D/DRC Case

1001 Senate Street

DESIGN/DEVELOPMENT REVIEW COMMISSION
BAILEY BILL APPLICATION
HISTORIC PROPERTY
EVALUATION SHEET
Case #9

NATURE OF REQUEST: Request approval for preliminary certification for Bailey Bill and a Certificate of Design Approval for exterior changes

EXTERIOR ELEVATIONS

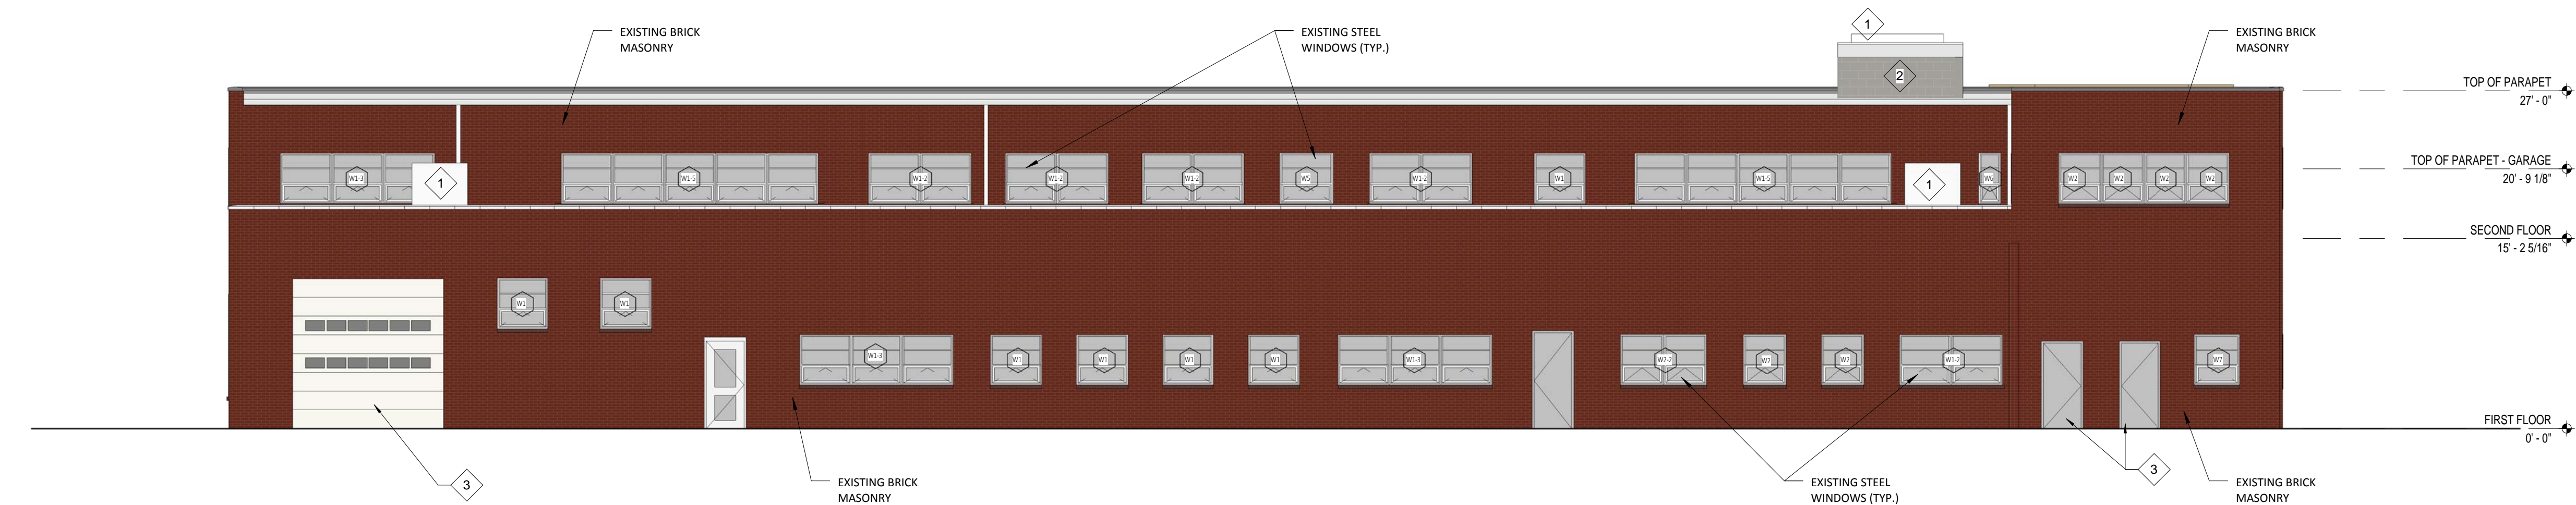
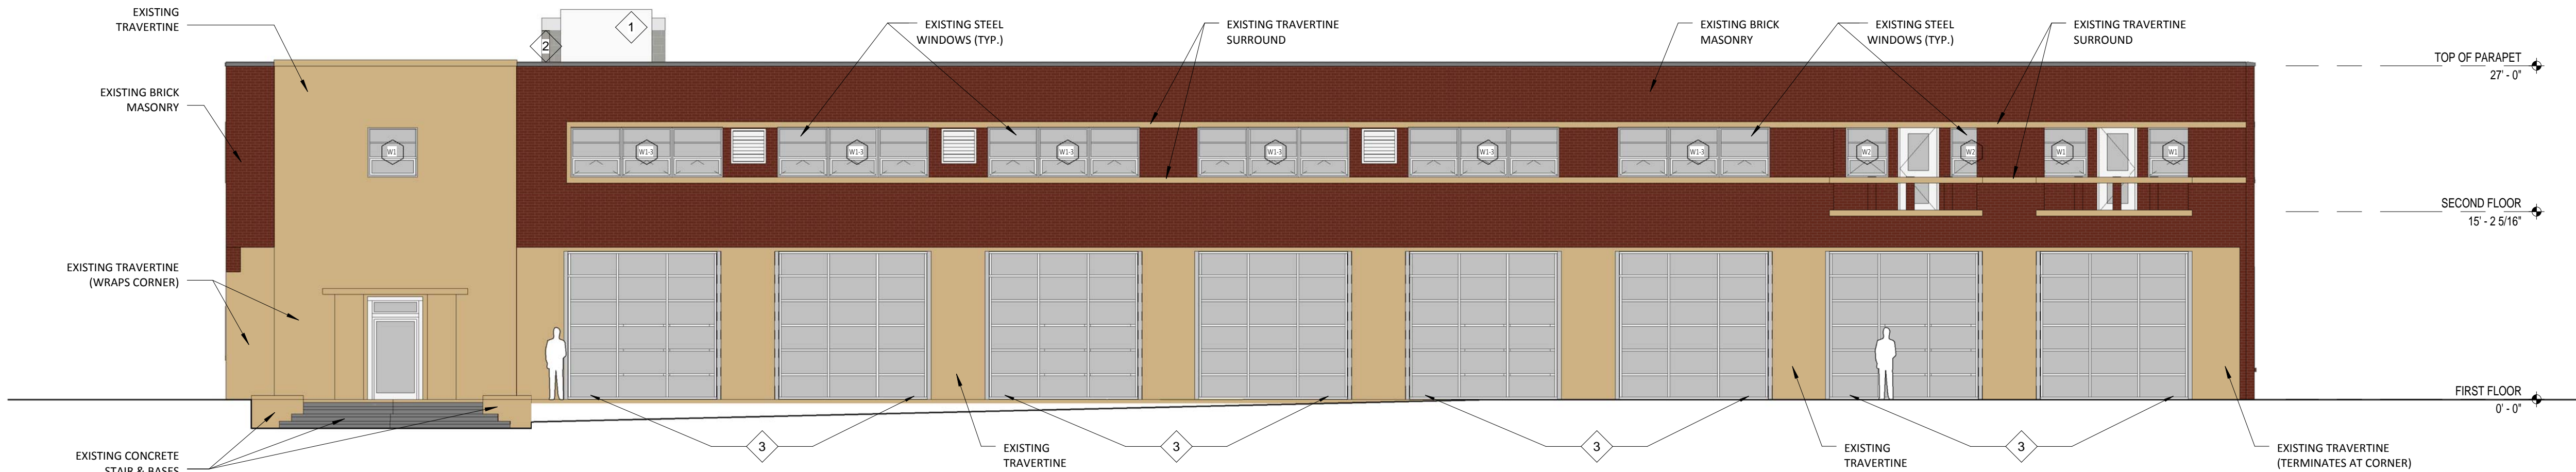
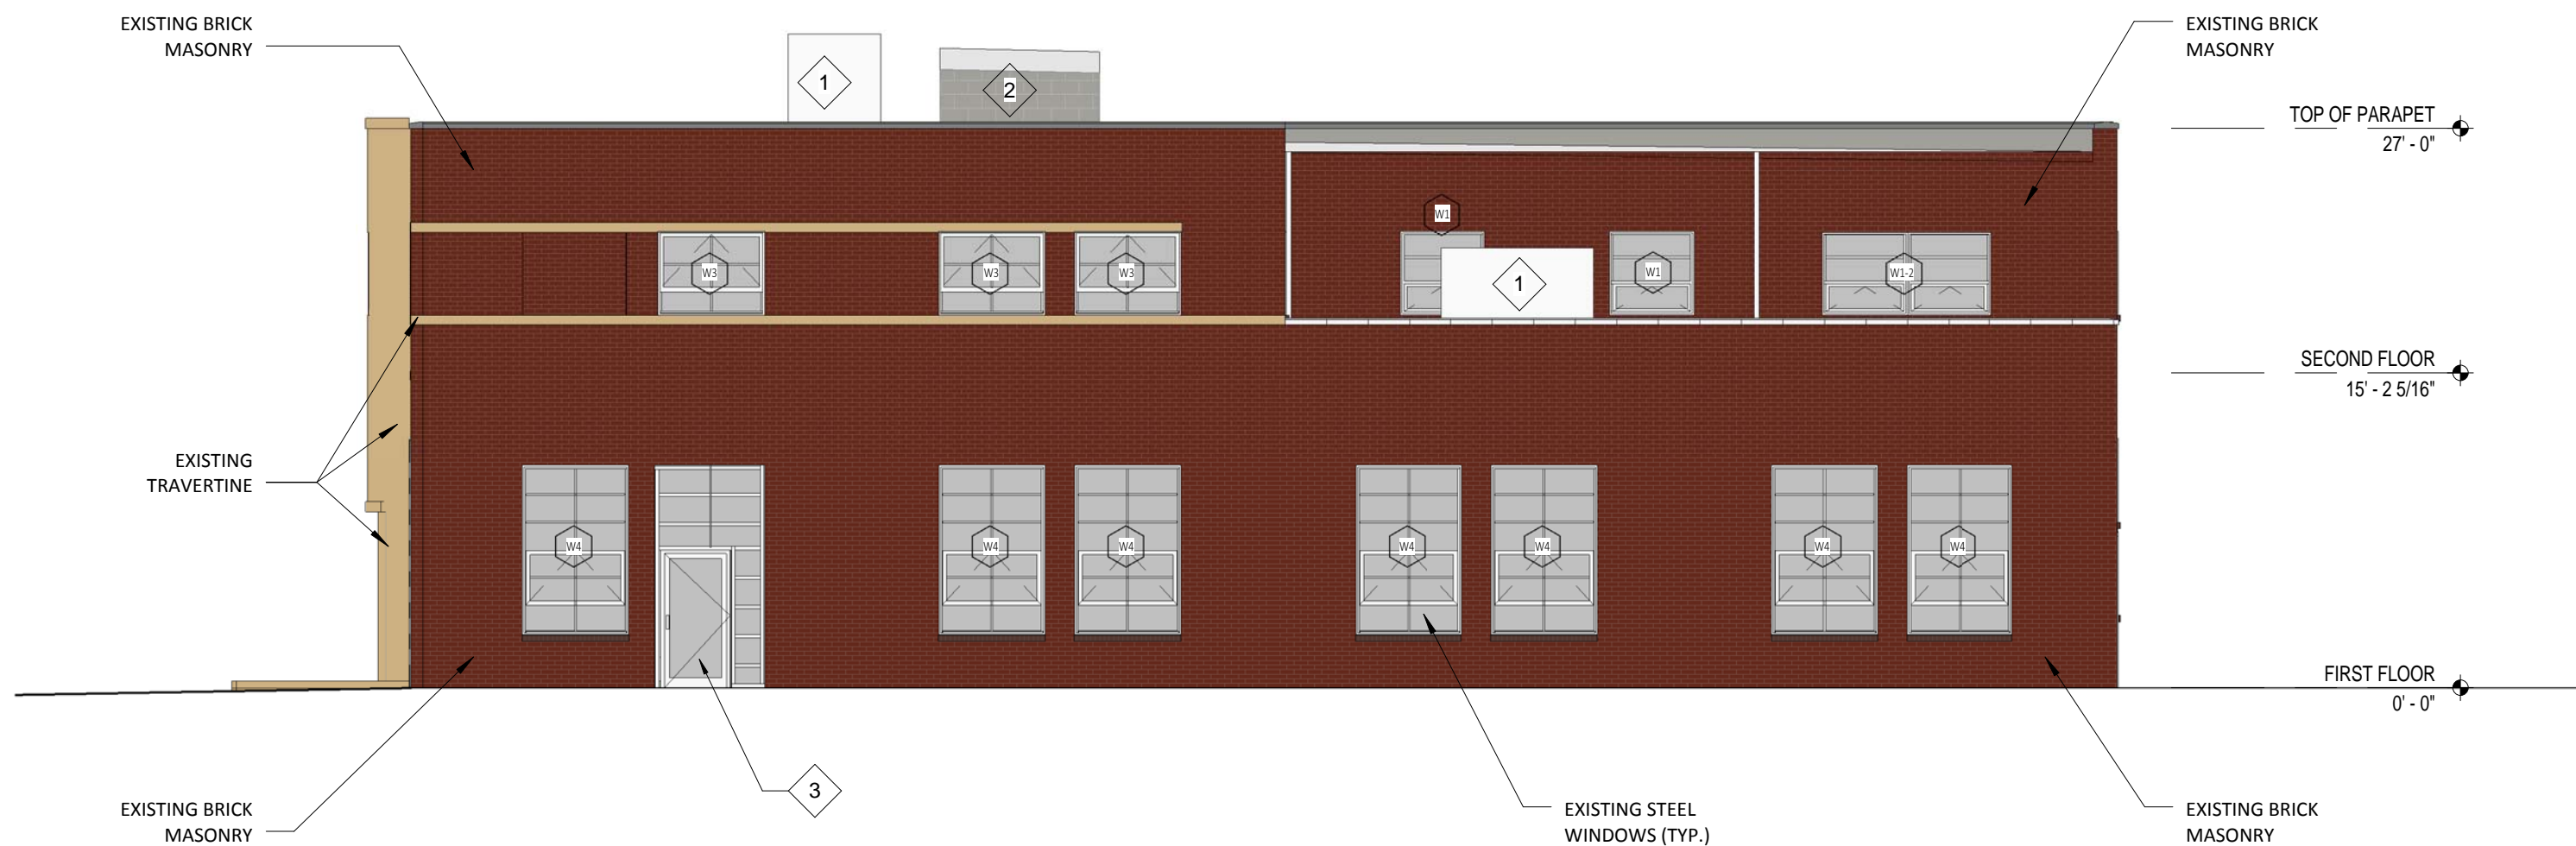
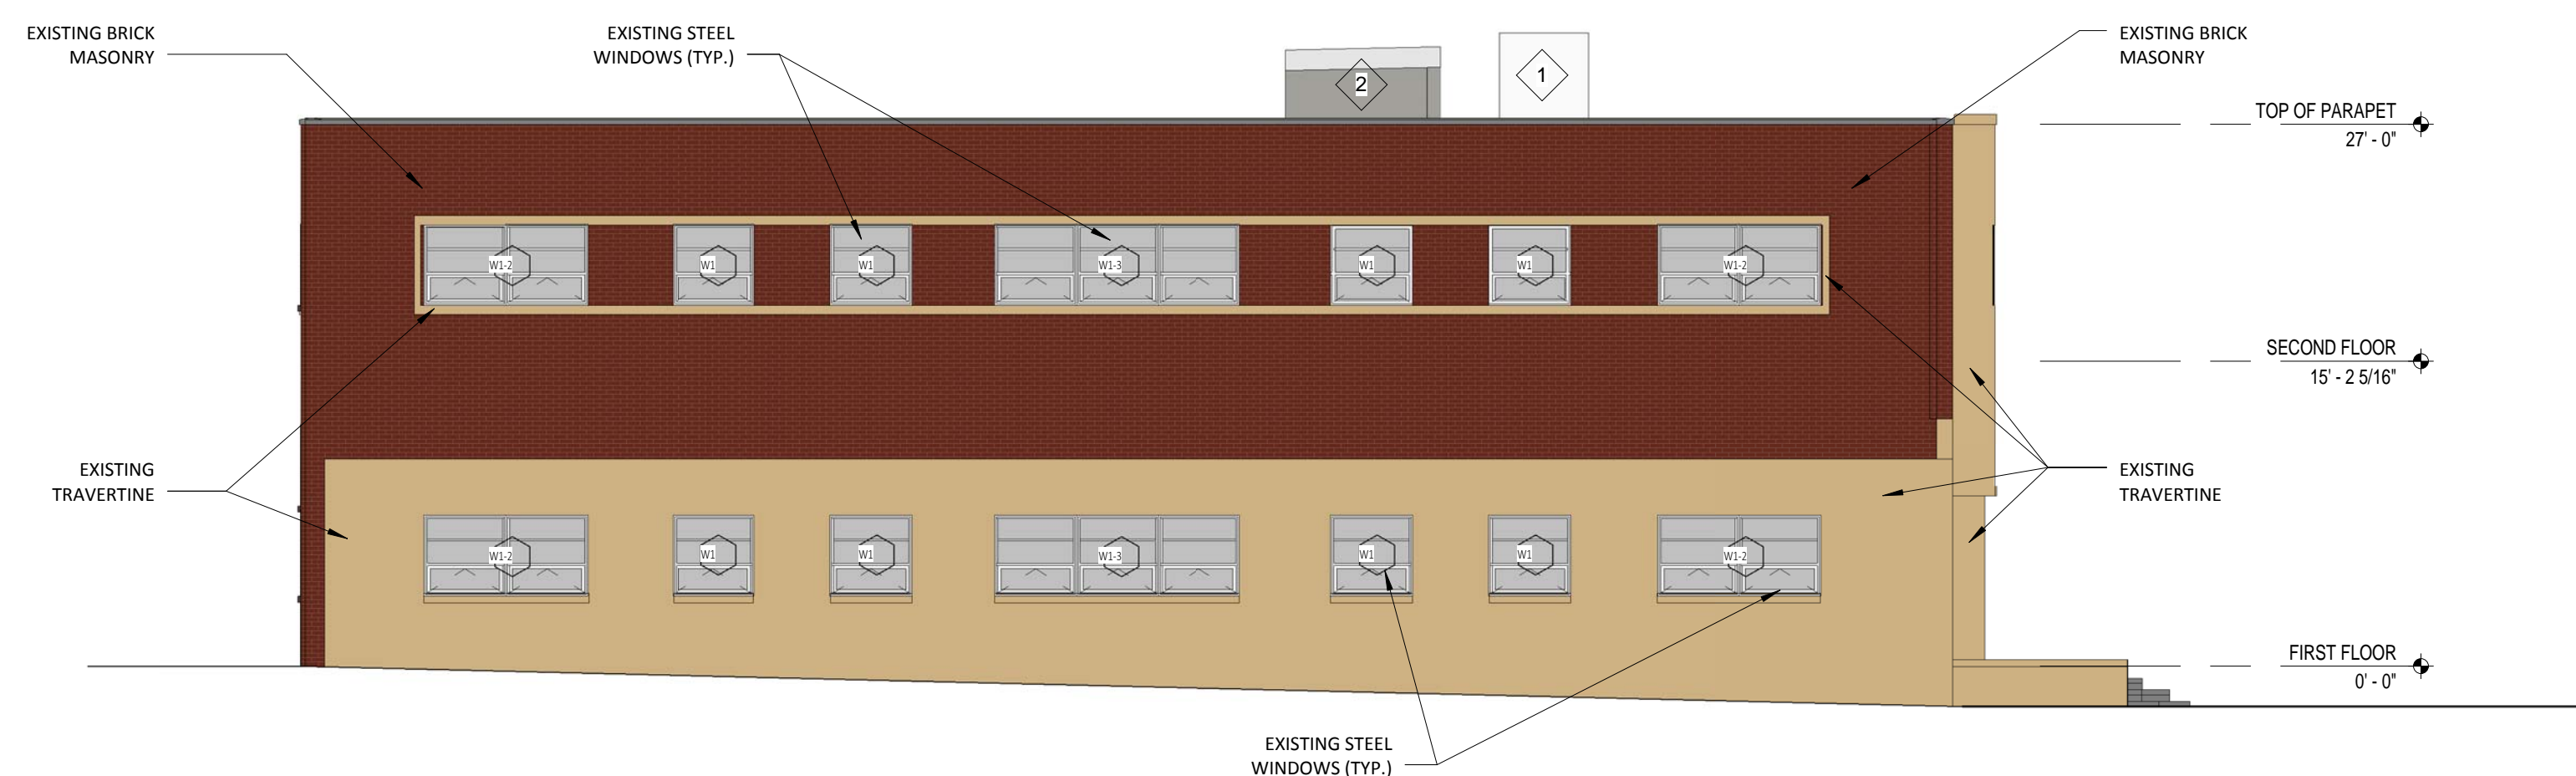
Significant changes to the building will include new garage doors in each of the bays of the garage on the south side of the building. The original roll-up doors, which are severely utilitarian and primarily character defining in terms of their function, have not been used in years and they and their mechanisms are in various states of repair. Additionally, the building's first floor will be divided among several different tenants, each of whom will require access/storefront on the south side of the building, so each of the bays will end up serving this purpose. Staff and the applicants discussed the idea of installing the original doors, if possible, in a raised position and then introducing a new fixed storefront system in each of the bays. However, after consideration, staff's analysis is that maintaining the function of the doors is a priority in understanding the original building and its function. Staff is working with the applicants on the design of

new roll-up doors which will work like the originals while still providing pedestrian entry when the doors are lowered. The new doors will be more transparent than the originals but ideally will reflect their horizontal lines, which are the most striking feature of the original doors. Please note that the doors shown on the elevations are for conceptual purposes only since the design is still under discussion.

On the east side of the building, a window opening will be lengthened to accommodate a door needed for emergency egress; likewise, two windows on the north side of the building will also be removed to allow for doors in their stead (to the utility areas in the building). Otherwise, most changes are on the interior of the building.

As stated above, the doors are in various states of repair and staff finds their functionality to be their character-defining feature. New doors should emphasize the horizontal to reference the original design of the doors and that of the building.

- *Staff to work with applicants on the design of the garage doors and will grant final approval of the design*
- *Staff to review any replacement materials necessary for the building*
- *Staff to review final signage*
- *All other details deferred to staff*

1 ROOF PLAN
SCALE: 1/8" = 1'-0"

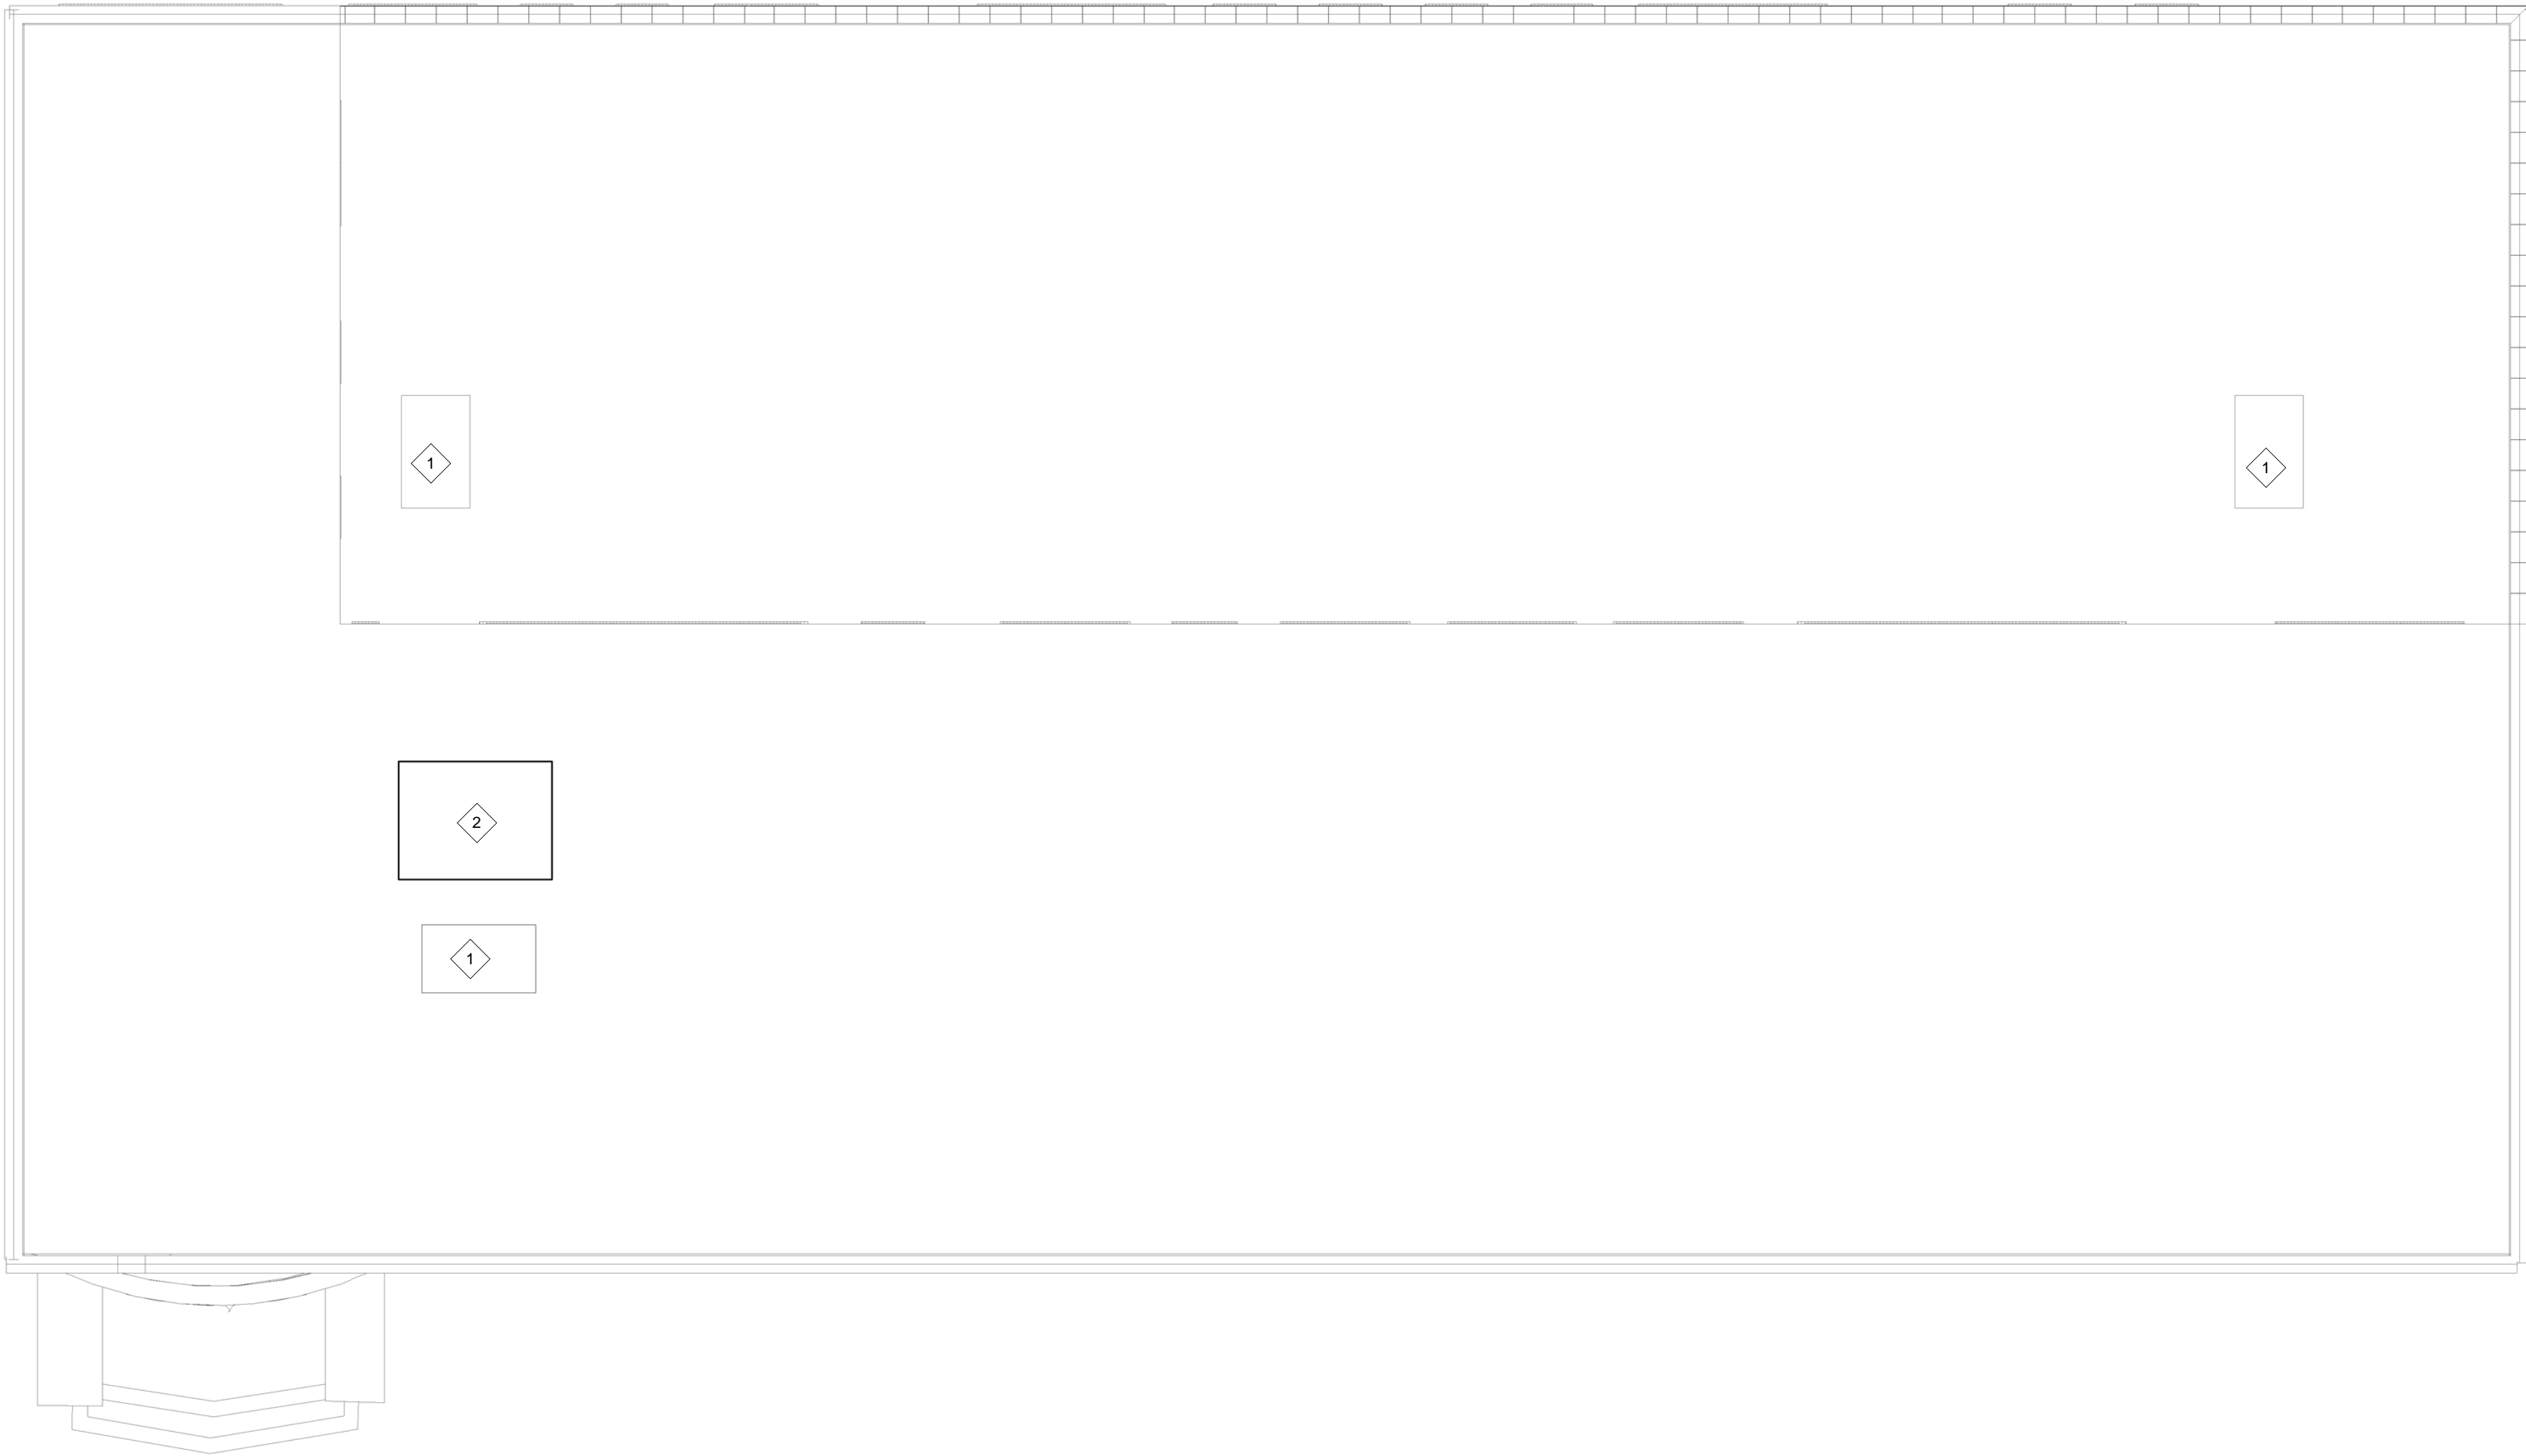
Much of the work on the exterior of the building is repair and rehabilitation. Plans are to rehabilitate the original steel windows and to install insulated storms on the interior of the windows, replacing glass only as necessary. The brick and travertine on the exterior of the building has suffered a bit over the years and will be carefully cleaned according to National Park Service recommendations. Any repointing which needs to be done will match the original mortar color, profile, and composition. The existing roof (not visible) will be replaced with a TPO roofing system. HVAC units and the housing for a new elevator will be rooftop and will either not be visible or will be screened appropriately.
